Appendix I Comments Received on Draft EIR/EIS

Subject: Draft Environmental Impact Statement for the El Camino Real Roadway Renewal Project on State Route 82, San Mateo County, California (EIS No. 20210072)

EPA’s DETAILED COMMENTS ON THE DRAFT ENVIRONMENTAL IMPACT STATEMENT FOR THE EL CAMINO REAL ROADWAY RENEWAL PROJECT, JULY 27, 2021

El Camino Real - SFPUC Pipelines

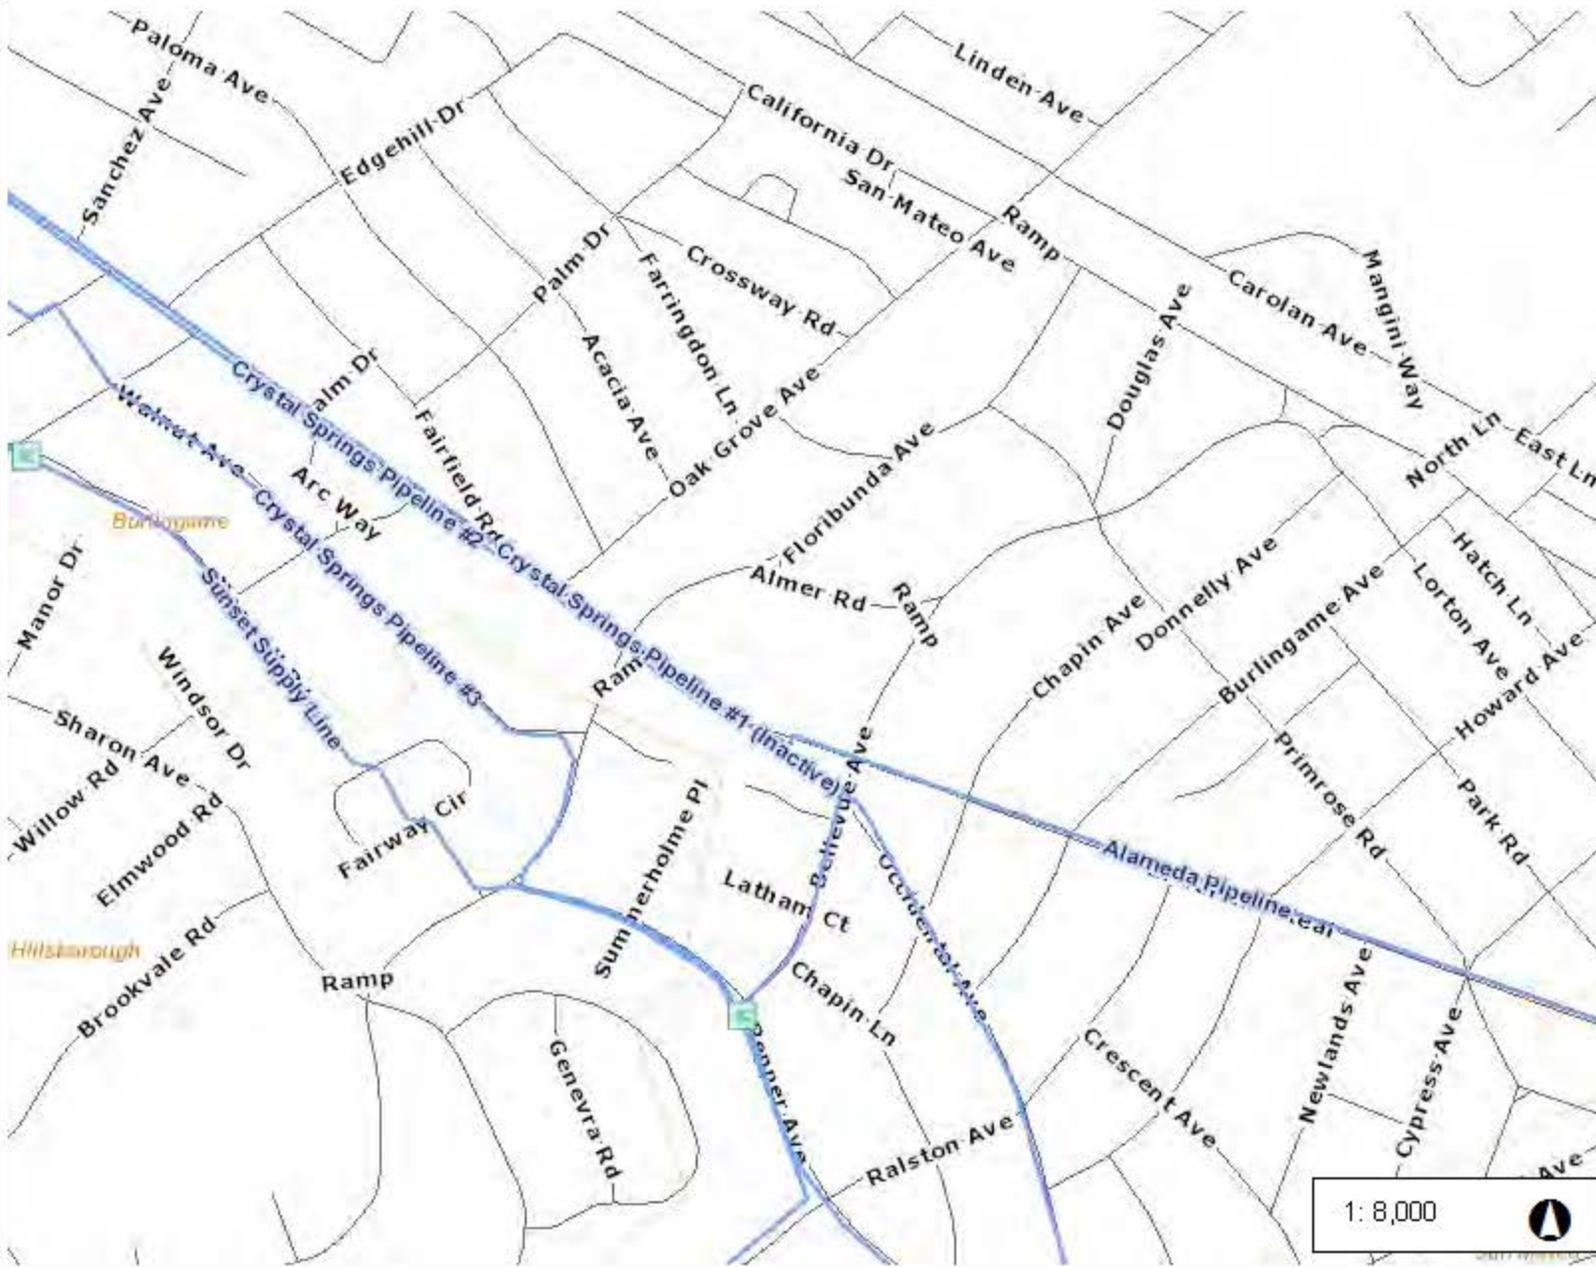
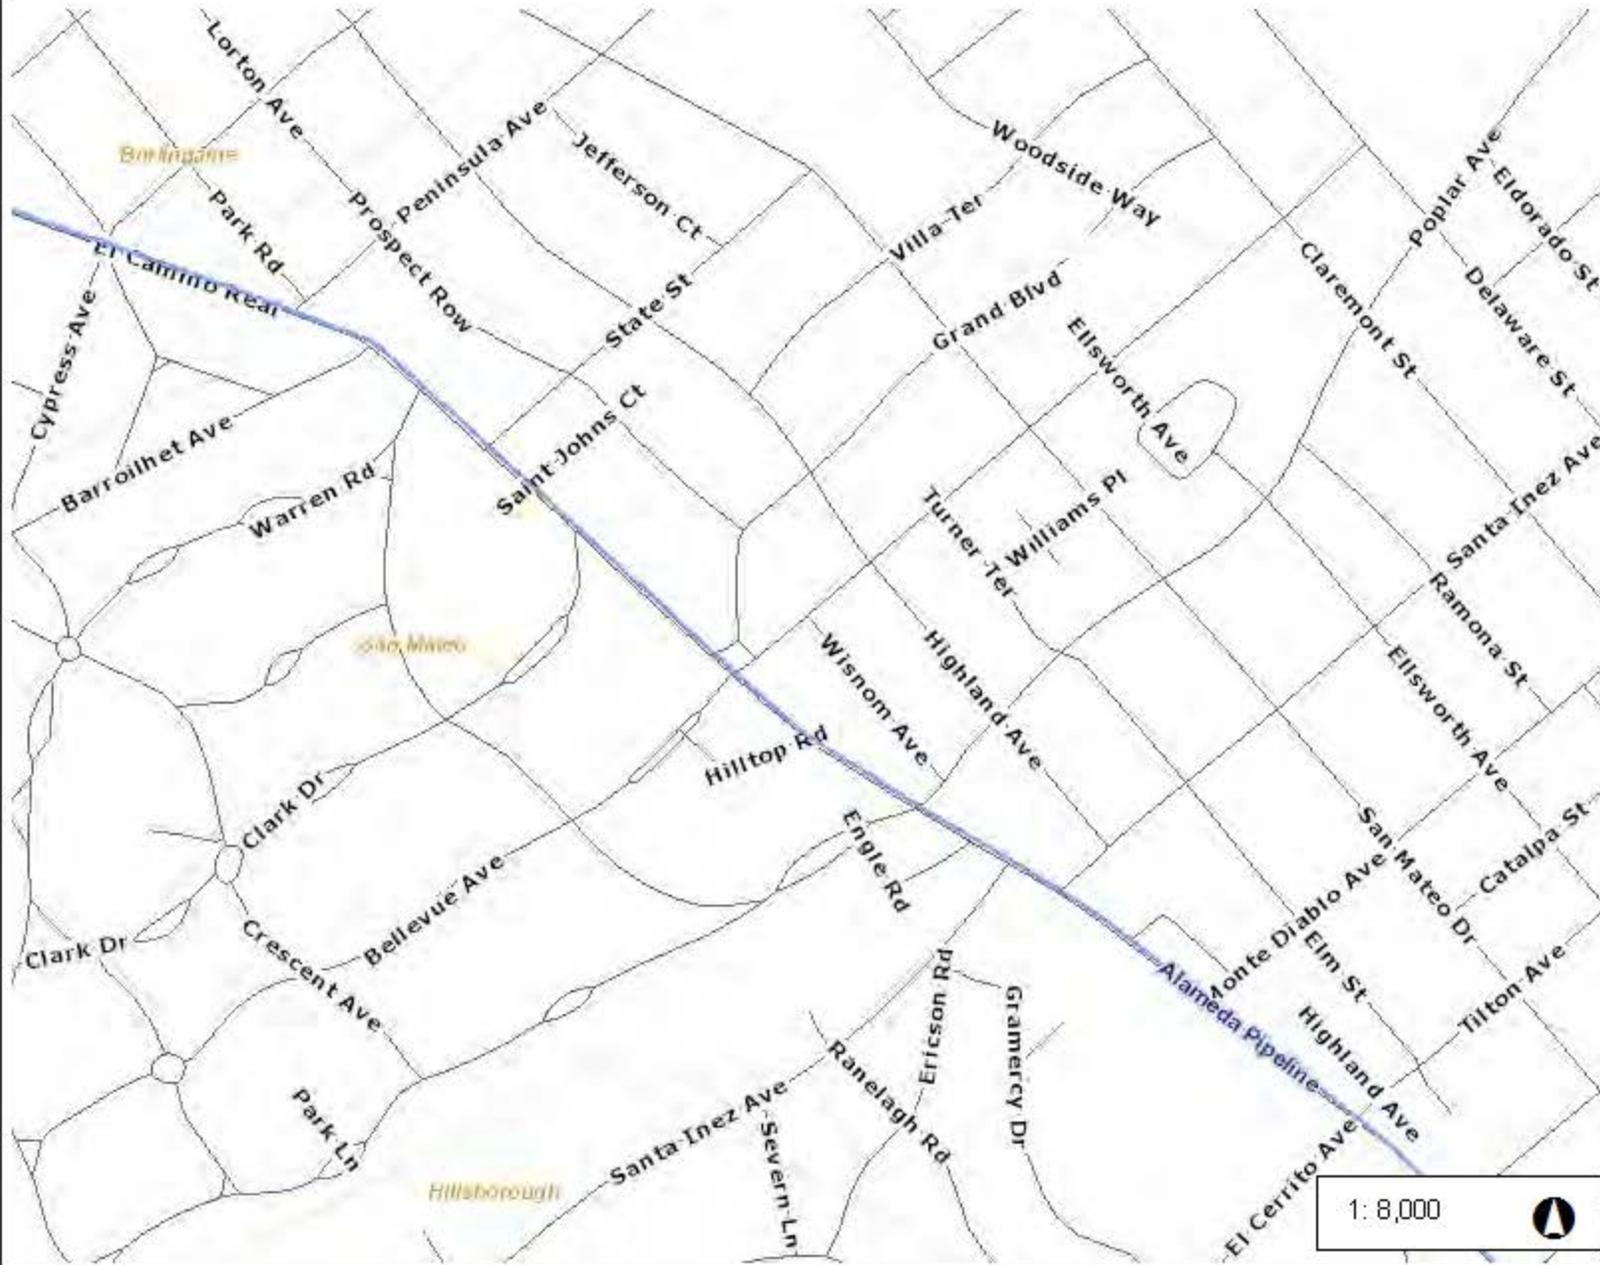
- The San Francisco Public Utilities Commission (SFPUC) requests that Caltrans describe the SFPUC's pipelines as part of the existing conditions at this site. The SFPUC has two water transmission pipelines located in the public right-of-way (ROW) directly under El Camino Real from East Santa Inez Avenue, in the City of San Mateo to Millbrae Avenue, in the City of Millbrae. Please note that, Crystal Springs Pipeline (CSPL) #1 is an inactive line, but CSPL #2 is an active pipeline for the Hetch Hetchy Regional Water System. For your reference, the attached maps show the approximate locations of CSPL #1 and #2.

- The SFPUC also requests that Caltrans describe potential impacts to CSPL #1 and #2 and include a statement that the project sponsor will work with the SFPUC to coordinate any future utility work/connection that involves working over, under or about the CSPLs in the public ROW. This coordination would involve distributing engineering plans to the SFPUC for review during preliminary and detail design.
